**SUSQUEHANNA STEAM ELECTRIC STATION
PROPOSED LICENSE AMENDMENT NO. 285 FOR
UNIT 1 OPERATING LICENSE NO. NPF-14 AND
PROPOSED LICENSE AMENDMENT NO. 253 FOR
UNIT 2 OPERATING LICENSE NO. NPF-22 EXTENDED
POWER UPRATE APPLICATION RE: REACTOR SYSTEMS
TECHNICAL REVIEW REQUEST FOR ADDITIONAL
INFORMATION RESPONSES**
PLA-6264

**Docket Nos. 50-387
and 50-388**

Attachment 2 to PLA-6264
Non-Proprietary Version of the Request for
Additional Information Responses

**Figure A.5 Liquid Velocity at Exit of Average Core
0.05 FT2/PD SF-BATT TOP 108F CPPU**

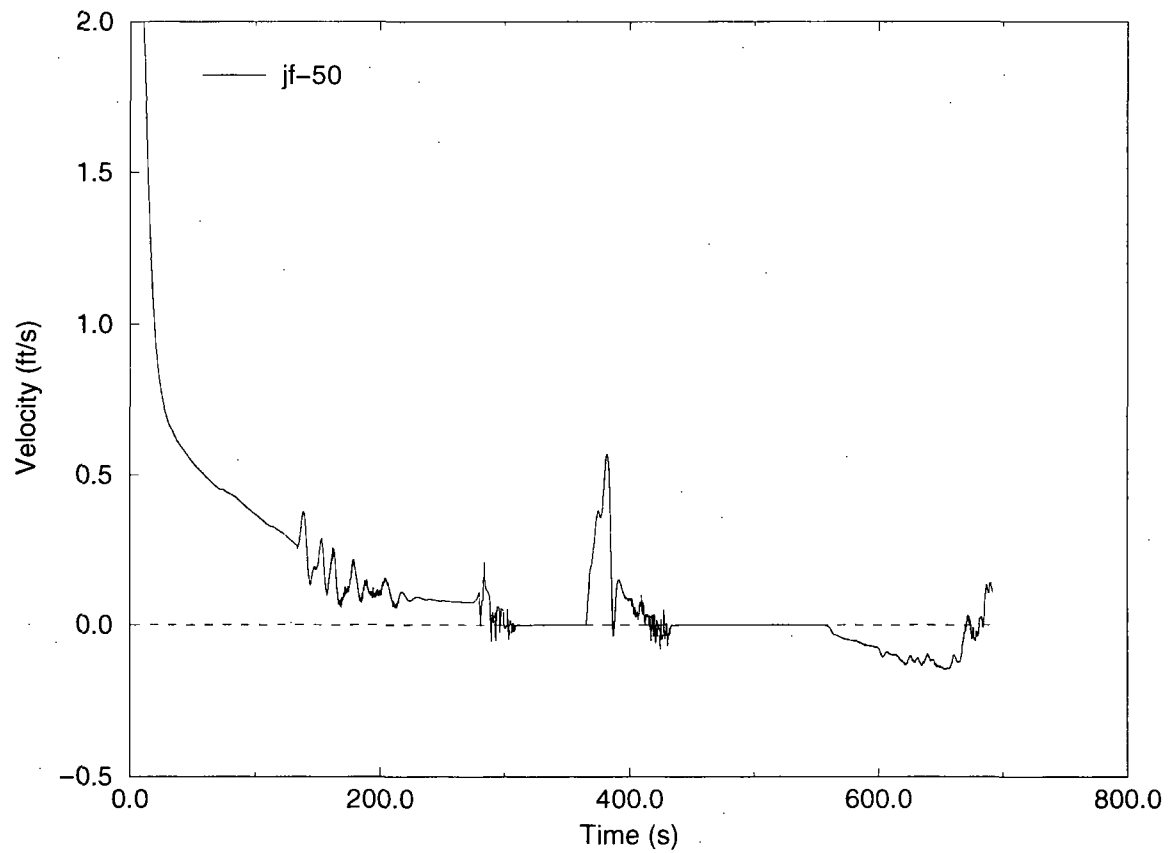
Provide plots of the liquid and vapor velocities at the exit to the core average and hot bundle regions. Also, mass flow into the hot bundle.

The requested liquid and vapor velocity plots are provided in Figures A.5 – A.8. The definition of superficial velocity used here is the velocity an individual phase would have if the entire flow region were filled with the selected phase at the predicted volumetric flow rate for that phase.

**Figure A.10 Liquid Mass in the Core Average Nodes
0.05 FT2/PD SF-BATT TOP 108F CPPU**

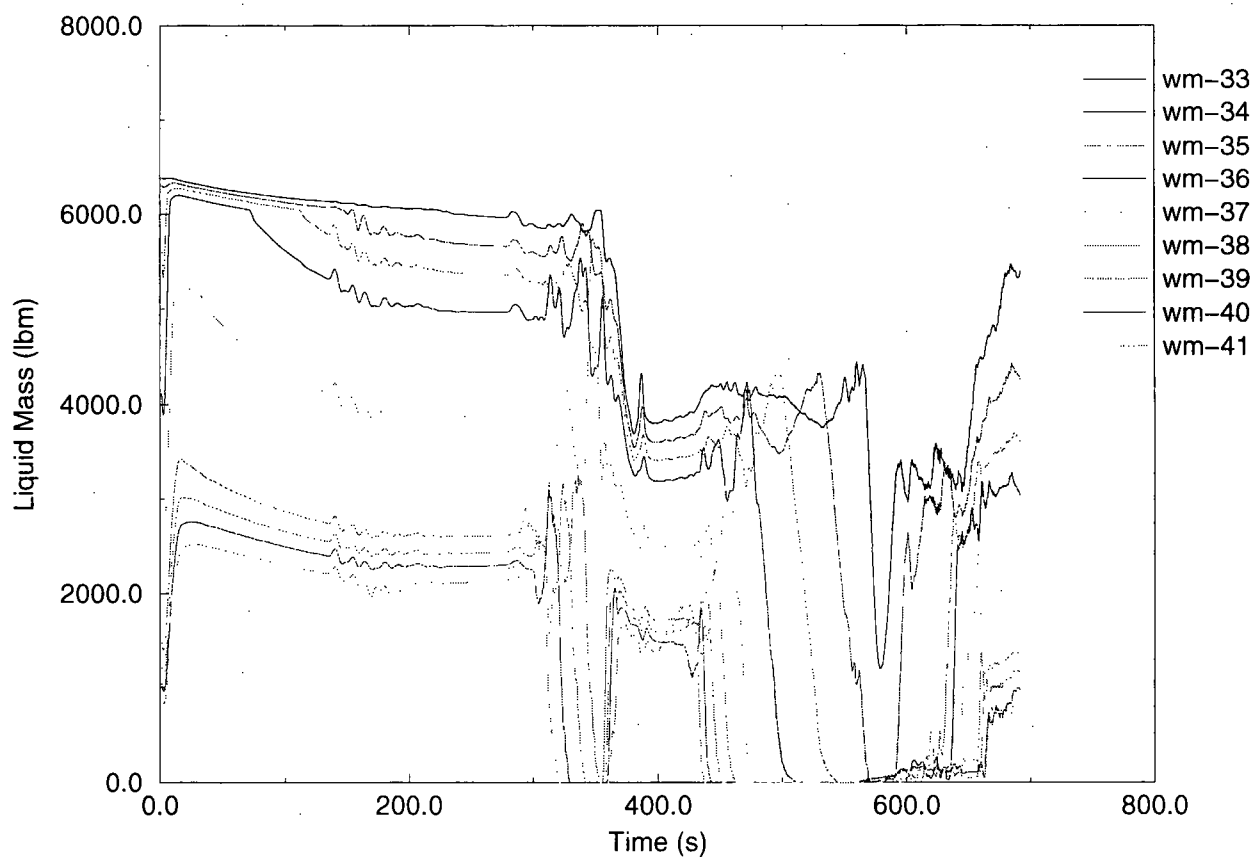
Provide the liquid levels and two phase levels in the core average and hot bundle regions.

The requested data is not available since the core volumes are homogeneous nodes. However, in response to the NRC request, the liquid mass in each of the core average and hot bundle core nodes is provided in Figures A.10 and A.11. These figures illustrate how liquid moves through the core average and hot bundle core nodes during the LOCA.

**Figure A.12 Liquid Velocity at Inlet to Core Bypass
0.05 FT²/PD SF-BATT TOP 108F CPPU**

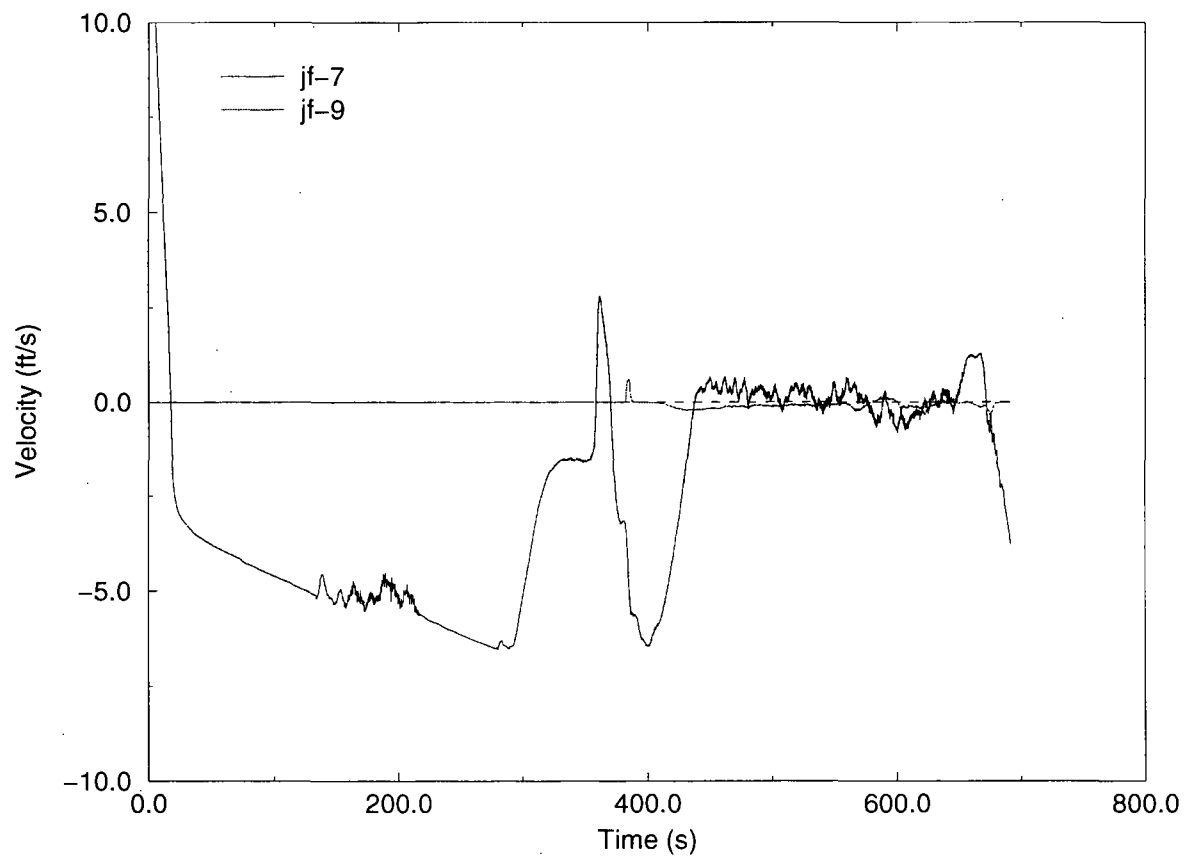
Provide the steam and liquid velocities at the inlet and outlet to the core bypass region.

The requested plots are provided in Figures A.12 – A.15.

**Figure A.16 Liquid Mass in the Hot Channel Nodes
0.05 FT2/PD SF-BATT TOP 108F CPPU**

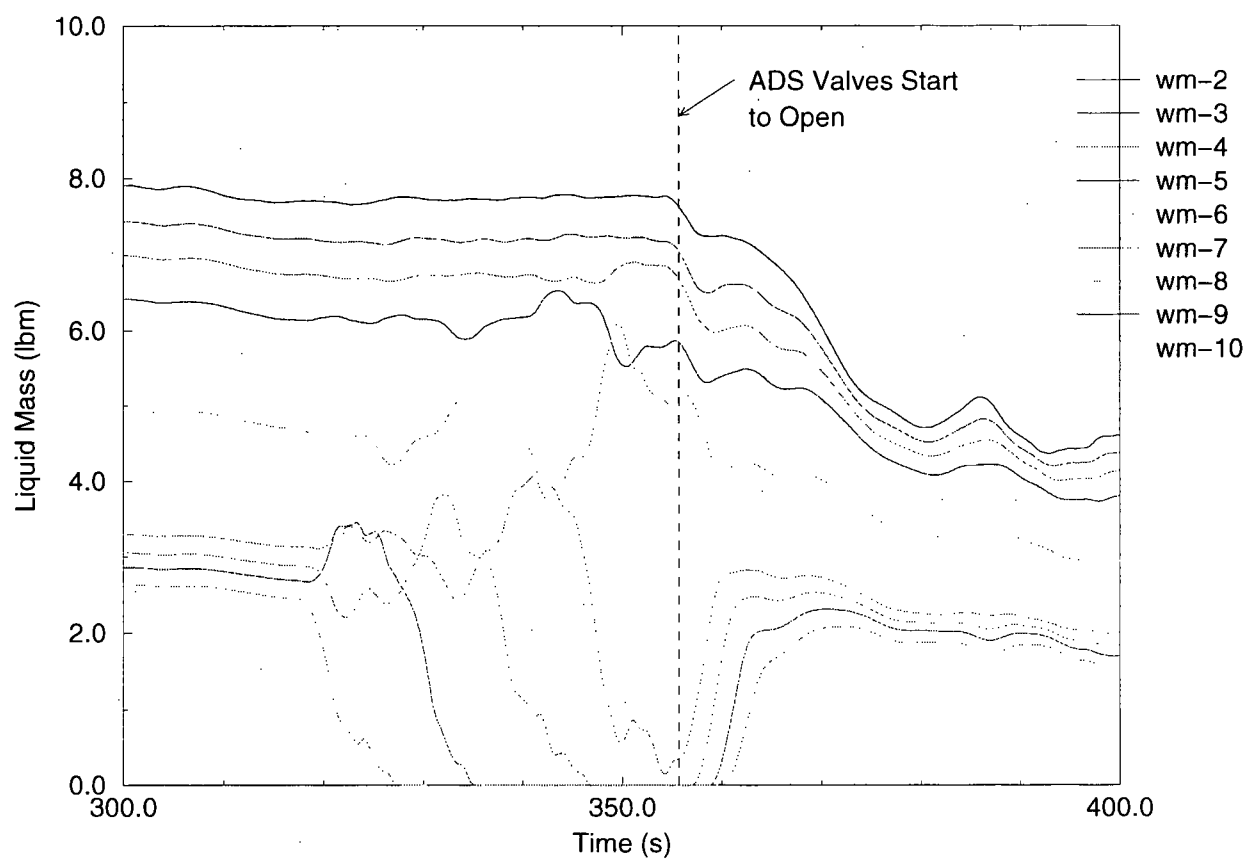
The heat up period before the safety injection is expected to be longer than shown in the SSES 1 and 2 limiting node quality plot (Figure A.24). Additionally, the quality stays lower than expected (about 0.06) for about 110 seconds (365 seconds to 475 seconds) before the heat up, and the heat up time before LPCS starts is about 83 seconds. It is expected that the heat up would be significantly longer and thus, the PCT would be higher than reported in the SSES 1 and 2 analyses. Since it is a top-peaked profile, the quality (void fraction) before heat up seems to be low and heat up time seems to be short. Please provide justification for the low limiting node quality and the short heat up time. If this is related to the modeling of LPCS cooling and CCFL, include this reasoning in your justification.

The decrease in the limiting node quality at about 365 seconds is in response to the rapid system depressurization resulting from opening the ADS valves at 355.7 seconds. The lower plenum begins to flash at 360.2 seconds. As illustrated in Figure A.16, opening the ADS valves caused the liquid mass in upper core nodes to increase (nodes 7, 8, 9, and 10). The decrease in the limiting node quality is due to the increase in the liquid mass in the node. The increase in liquid mass in the upper nodes results from the level swell associated with rapid system depressurization.
